Addendum ADD#3

Date: June 10, 2026
Project Name: Verona Housing
Project Address: 6094 Carleton Dr, Verona, ON K0H 0B8
Project Number: 26001

Structural Addendum #2

Client	Kingston Frontenac Housing Corp.
Address	6094 Carleton Drive, Verona, ON
File	25-10031PR
Title	Structural Plans
Sheet	S4-103

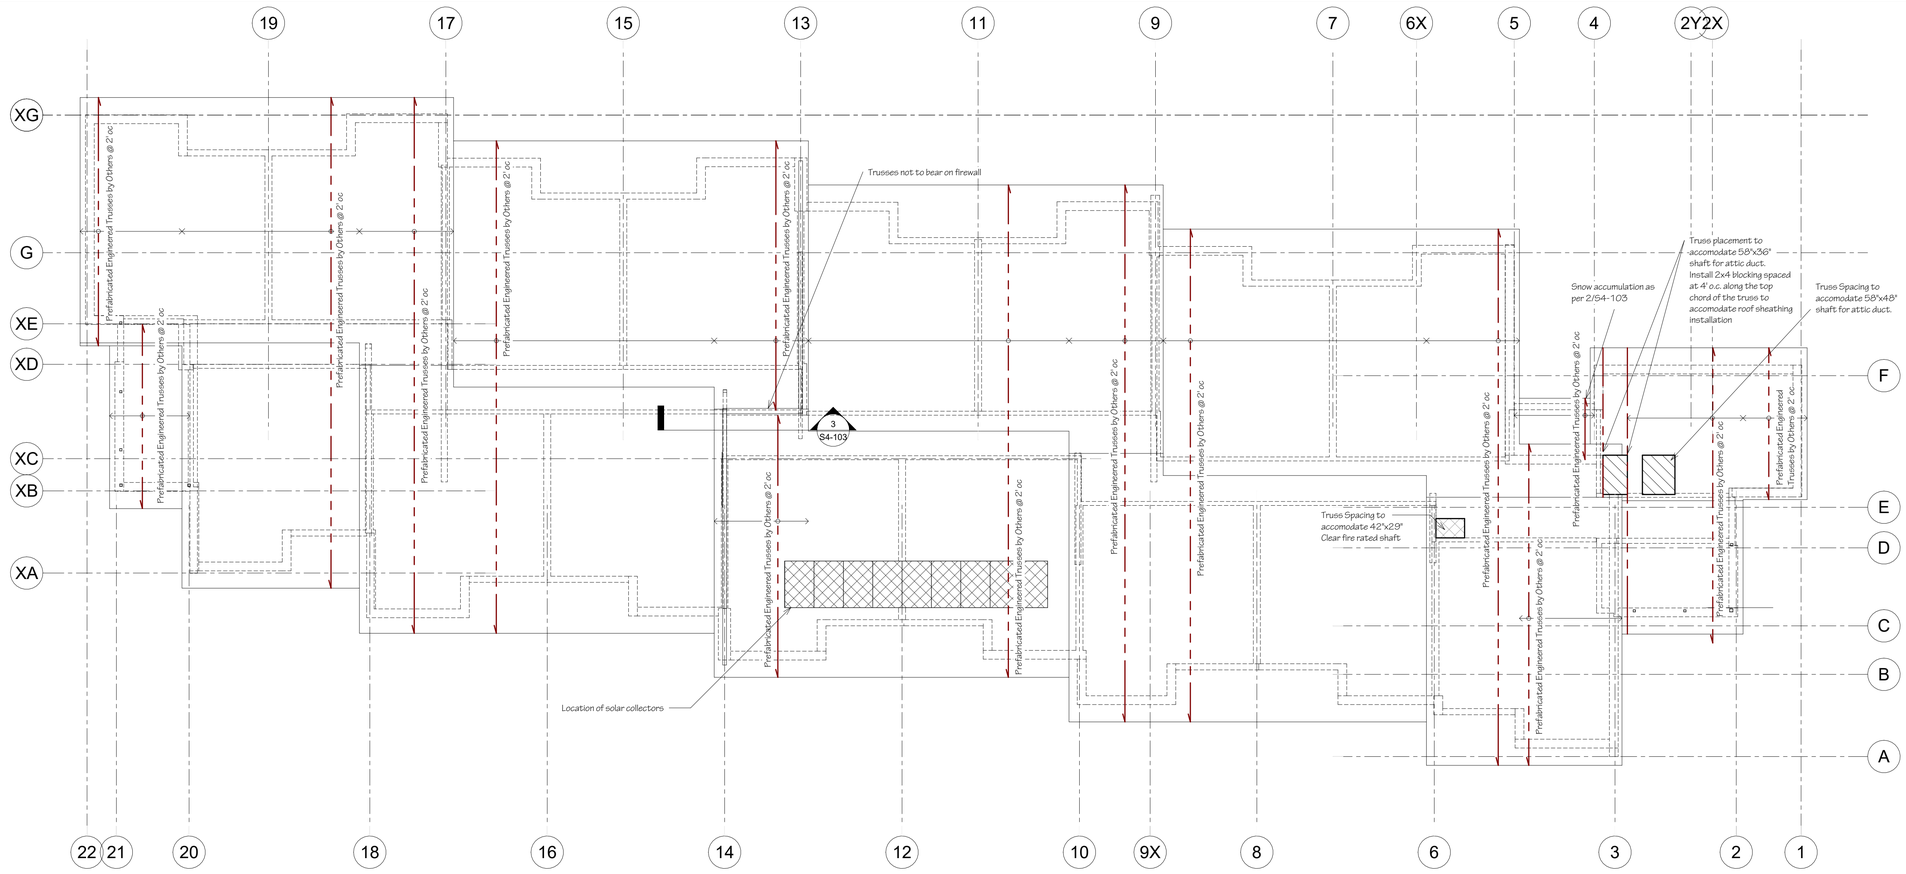
- Provided details 5/S4-103 and 6/S4-103 to show CMU and footing reinforcement in the new foundation walls.

SHEET NUMBER: E101A

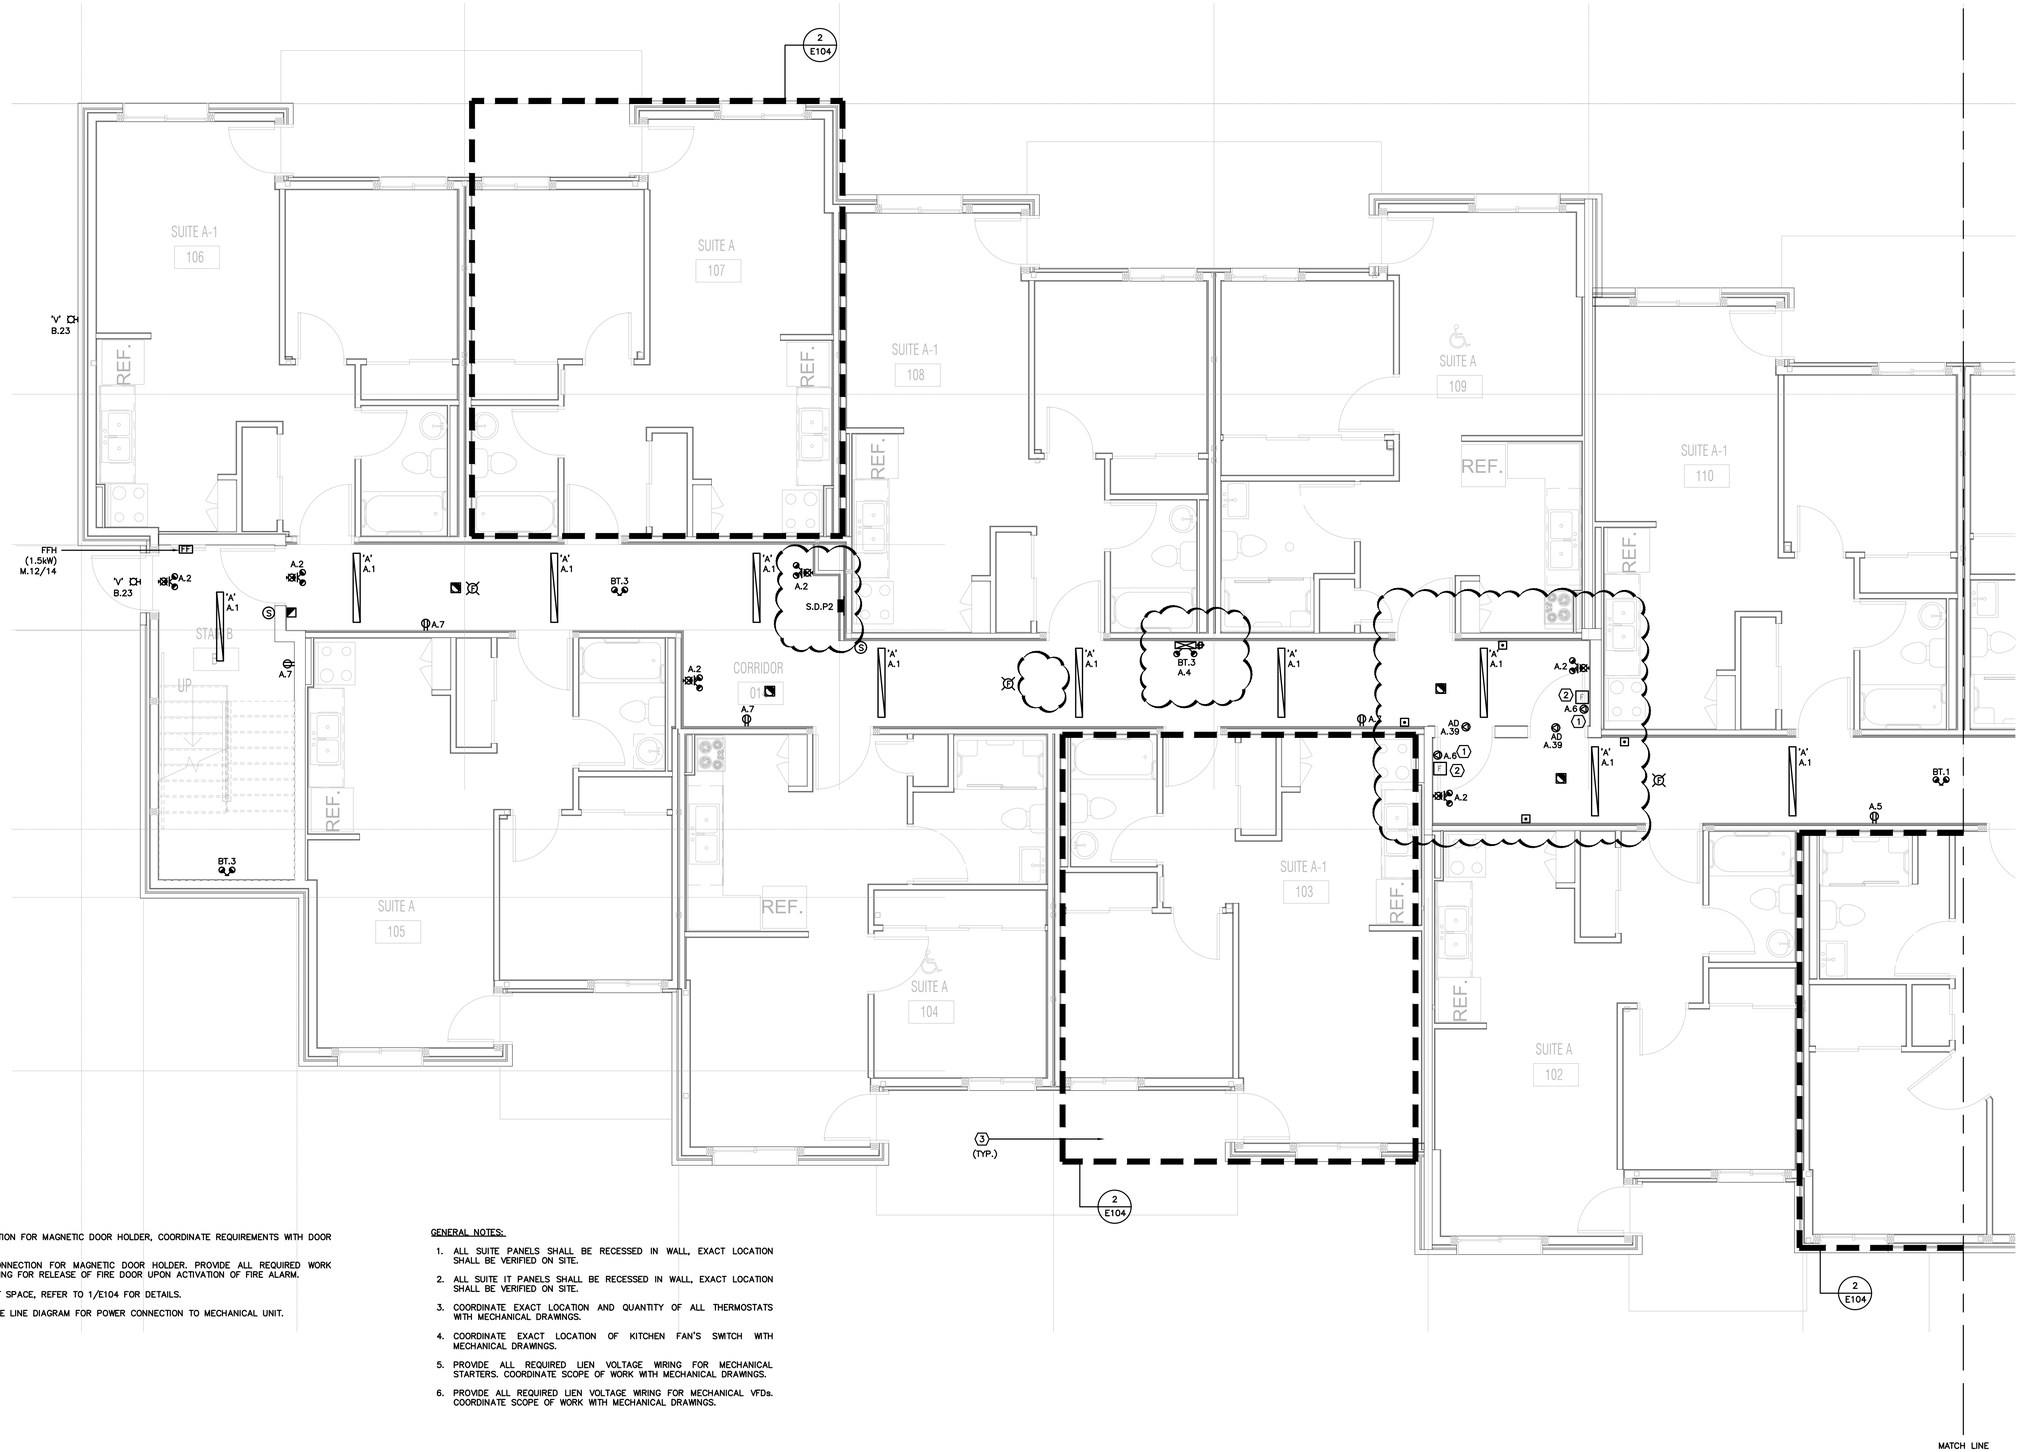
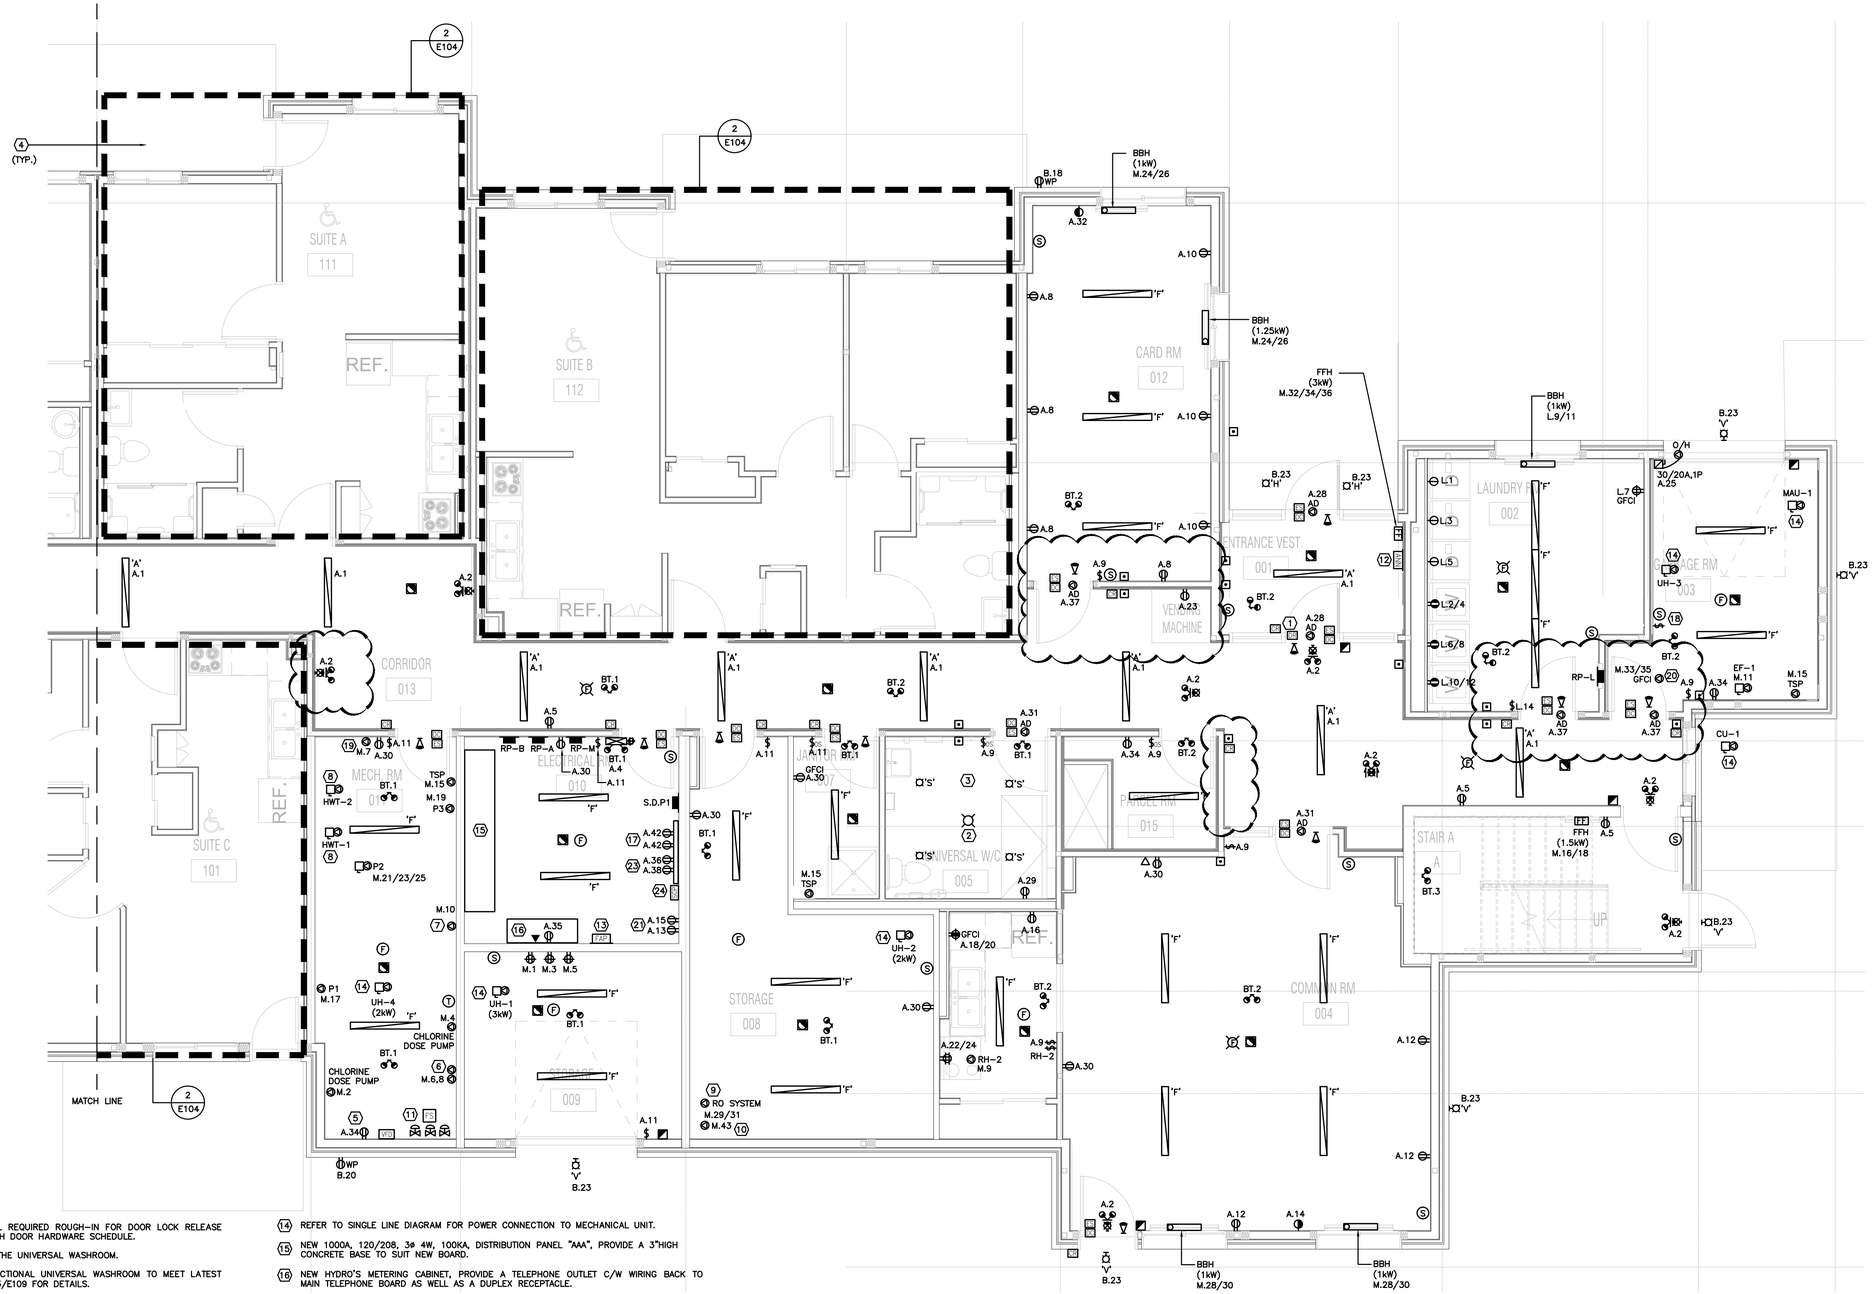
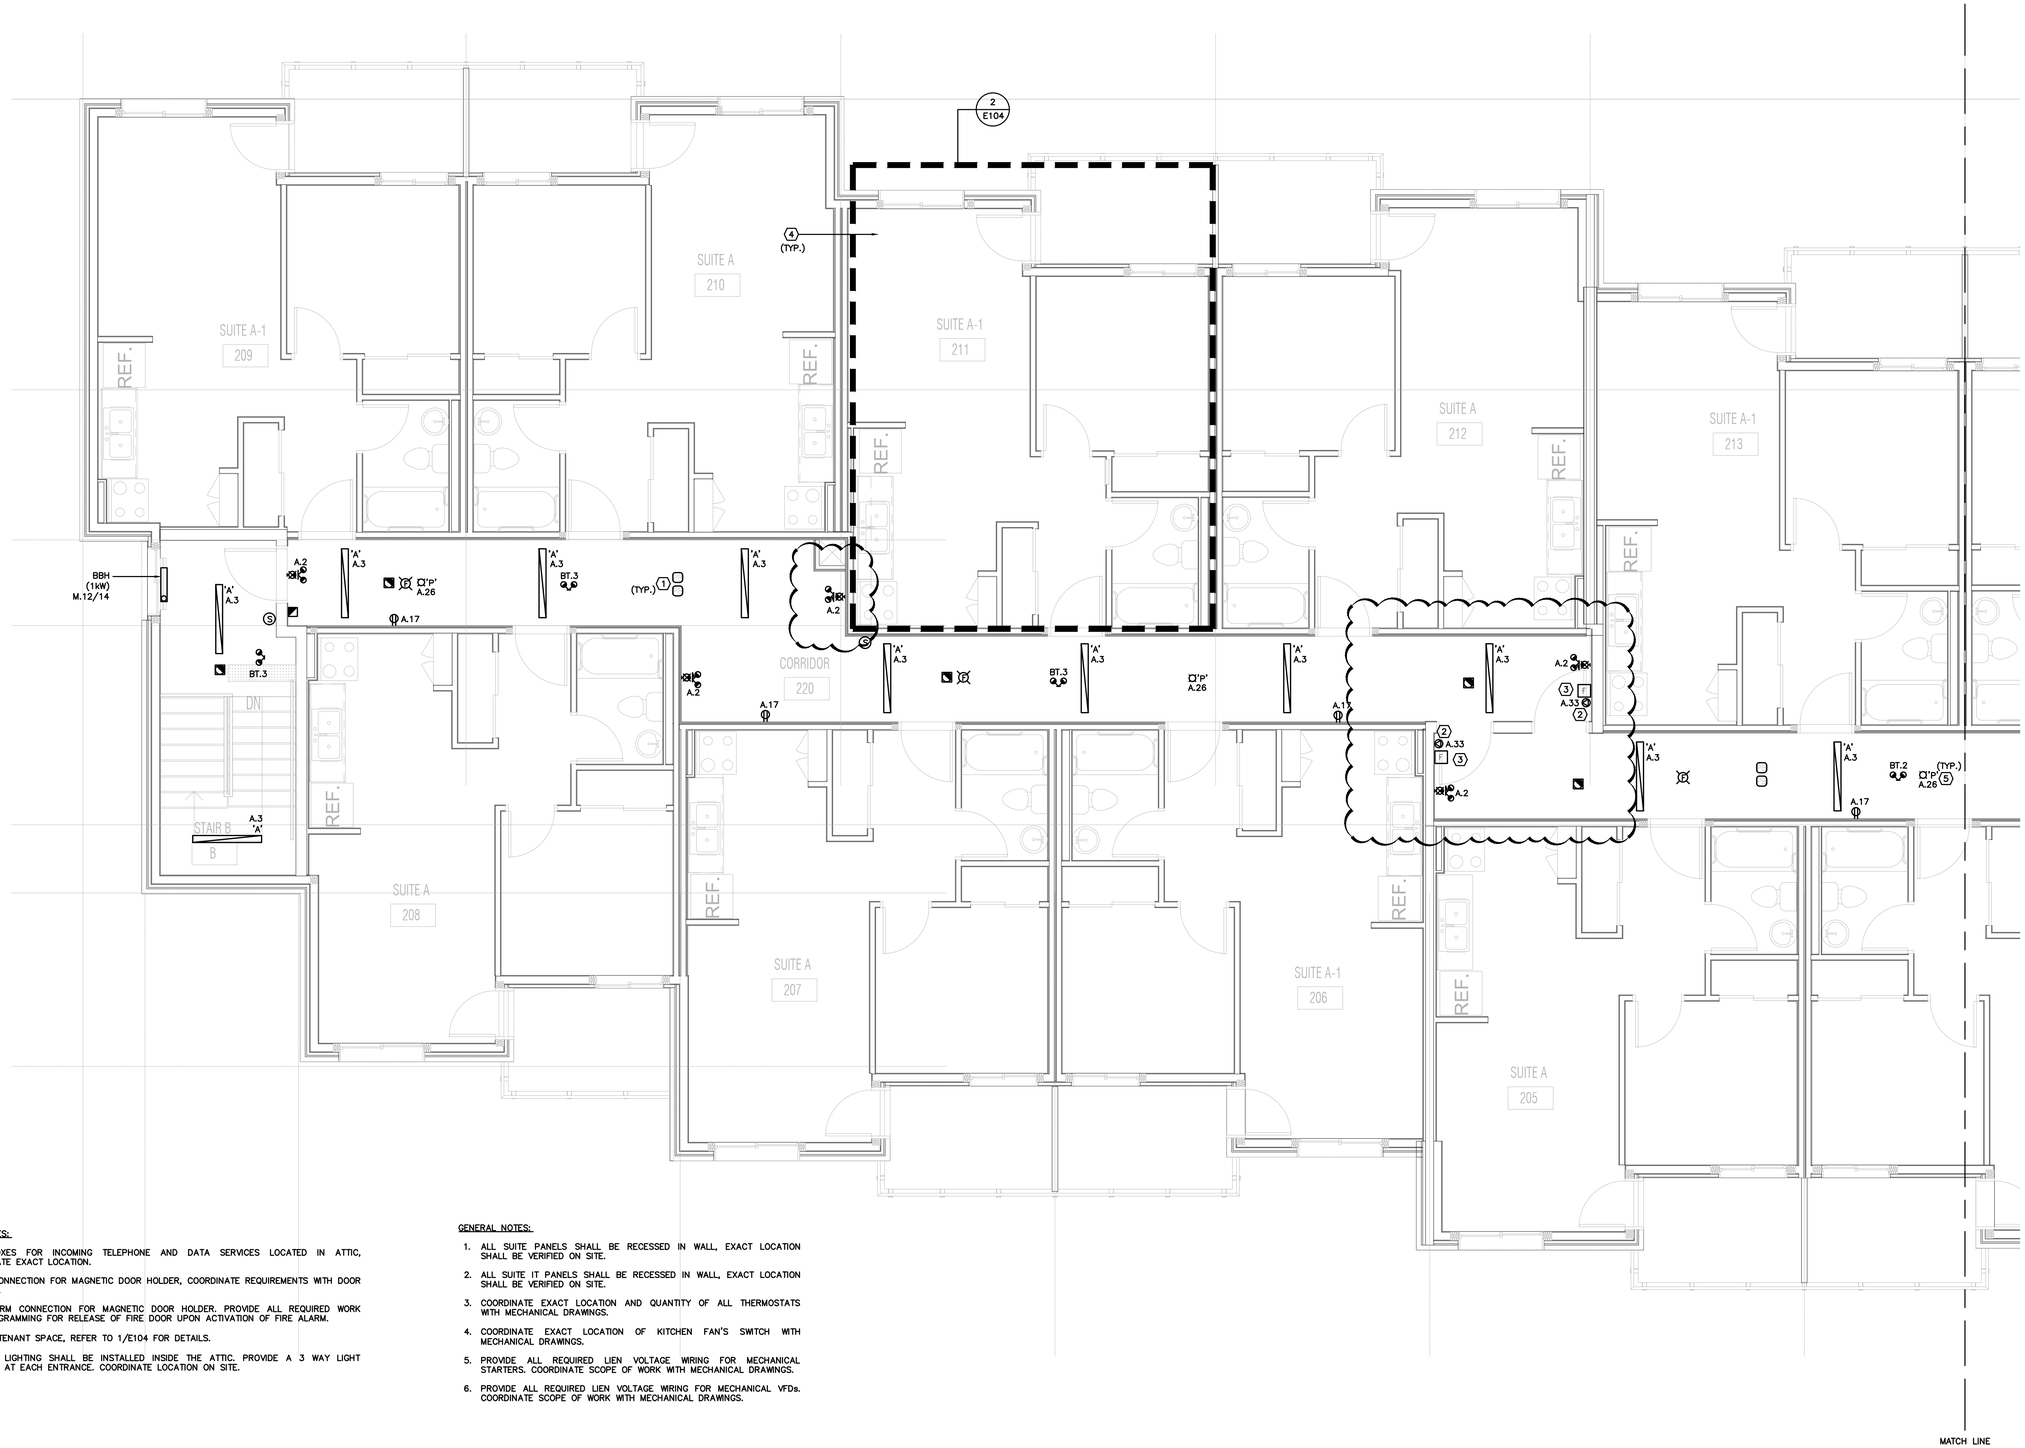
2. **Drawing E101A - E102B (Re Issued)**
   2.1. Revise the emergency lighting and exit signs as indicated.
   2.2. Provide new auto door systems as indicated.
